July 24, 2014
U7-C-NINA-NRC-140021

South Texas Project
Units 3 and 4
Docket No. 52-012 and 52-013
Response to Request for Additional Information

REVISED RESPONSE TO RAI 08.02-25 and 08.02-26:

Figure 1

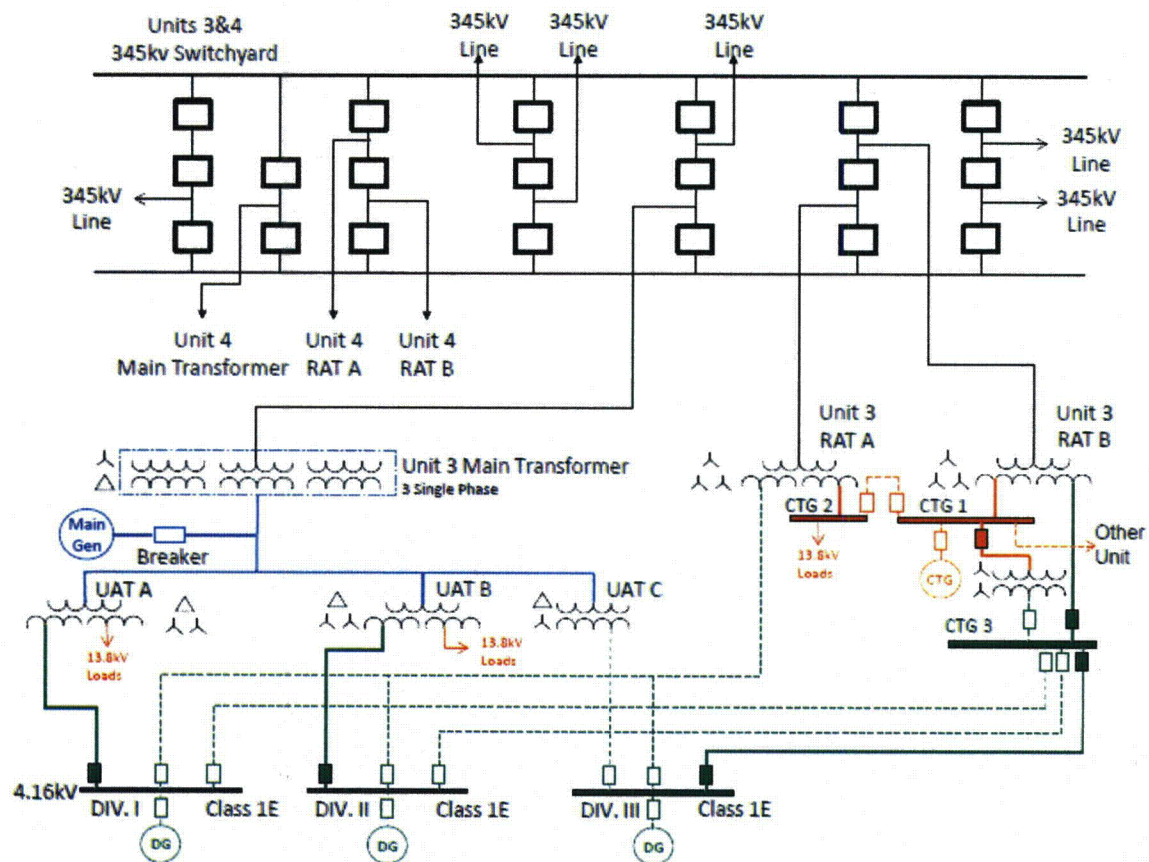
- ***If the important to safety buses are not powered by offsite power sources during at power condition, explain how the surveillance tests are performed to verify that a single-phase open circuit condition or high impedance ground fault condition on an off-site power circuit is detected.***

The Class 1E 4.16 kV safety busses at STP 3&4 are normally powered by offsite power sources during at power conditions. As shown in Figure 1, two of the Class 1E 4.16 kV busses are supplied with power from the main generator through the unit auxiliary transformers. The third Class 1E 4.16 kV bus is supplied from RAT-B. RAT-A is normally unloaded and in a standby mode. Open phase detection and alarm is provided for all three transformers (MPT, RAT-A, RAT-B) that are connected to the offsite grid.
